ERNIE BALL® MUSIC MAN®

SUB PASSIVE 2EQ BASS
WIRING DIAGRAM

REV C	DRAWN BY JHW	APPROVED BY DDG	DATE 2-23-04
SCALE NONE	TOLERANCE UNLESS SPECIFIED	N/A	PART NO. —

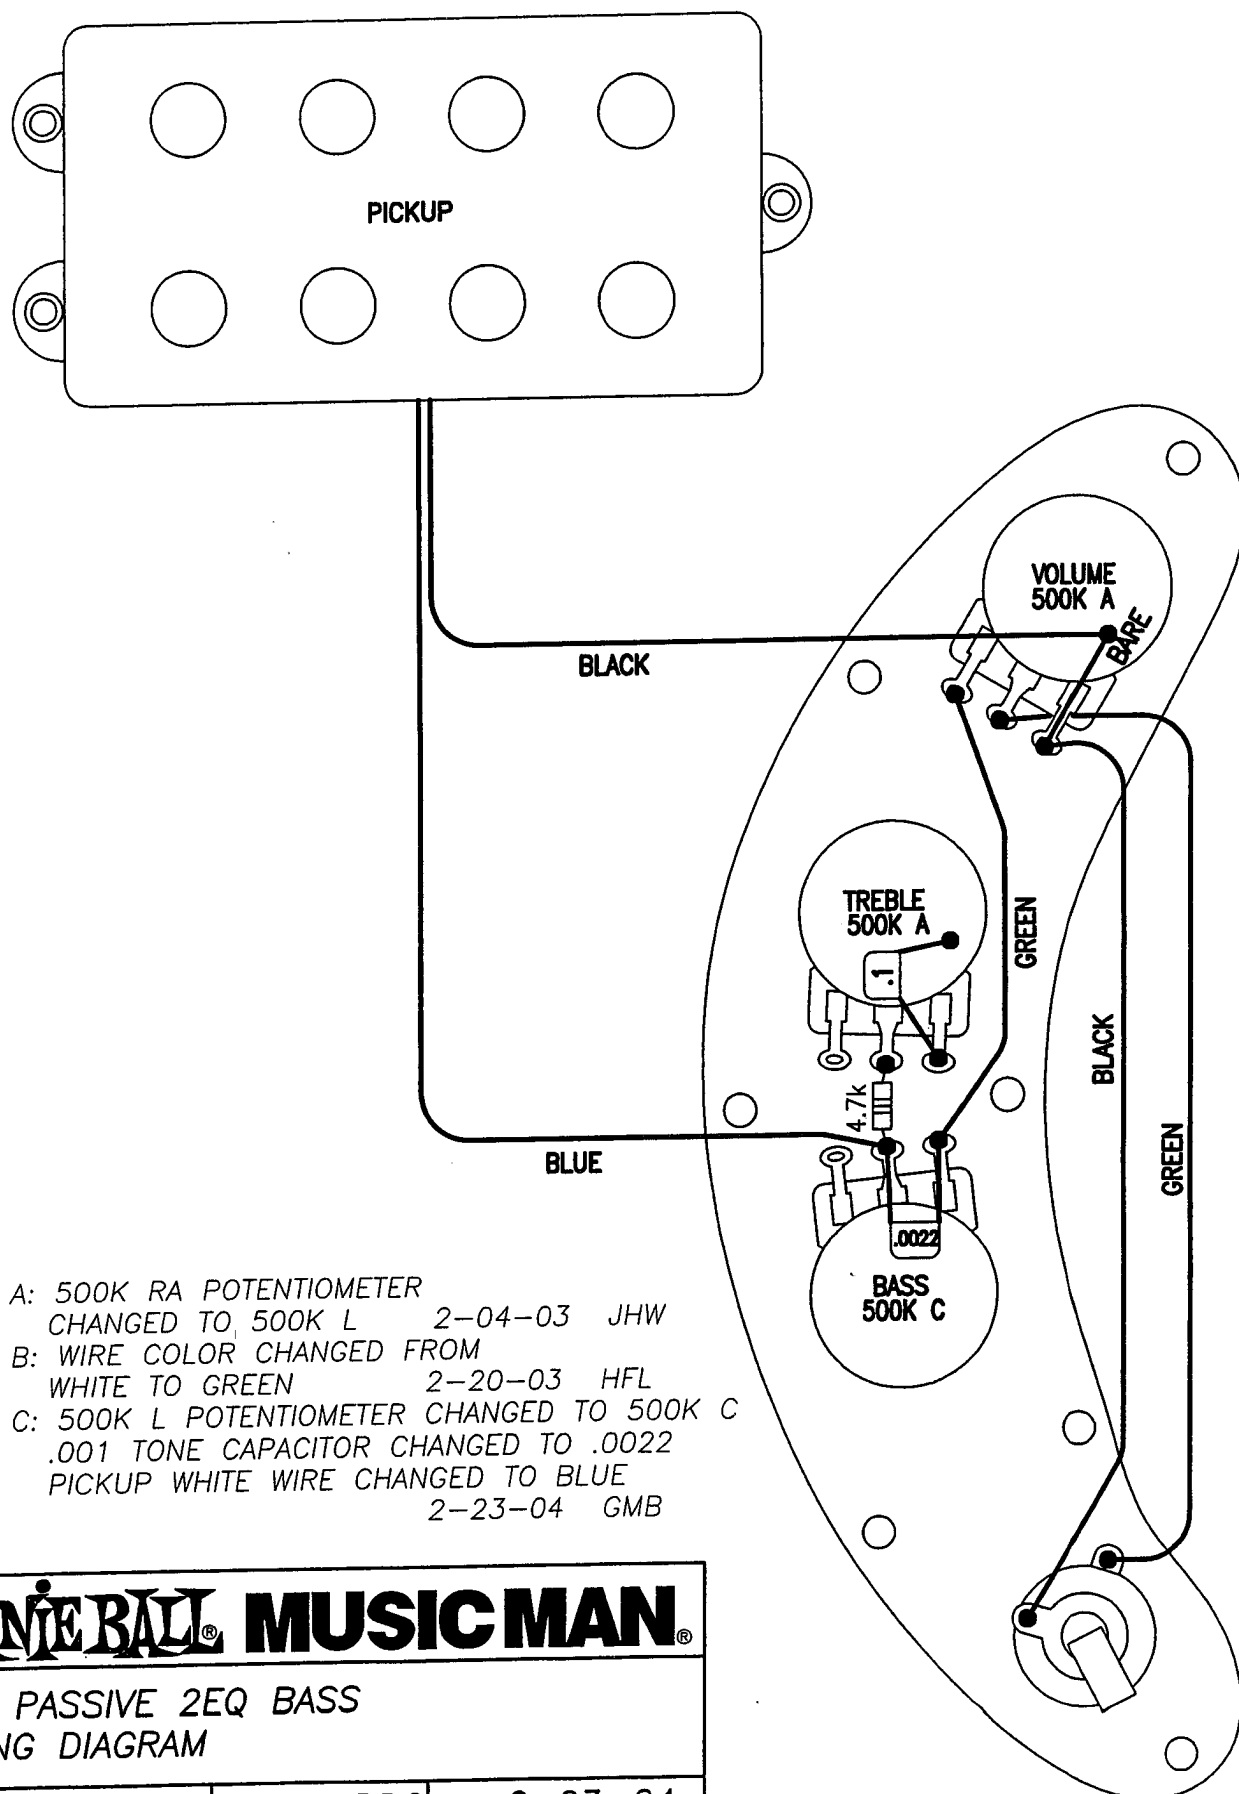
REV. A: 500K RA POTENTIOMETER
CHANGED TO 500K L 2-04-03 JHW
REV. B: WIRE COLOR CHANGED FROM
WHITE TO GREEN 2-20-03 HFL
REV. C: 500K L POTENTIOMETER CHANGED TO 500K C
.001 TONE CAPACITOR CHANGED TO .0022
PICKUP WHITE WIRE CHANGED TO BLUE
2-23-04 GMB
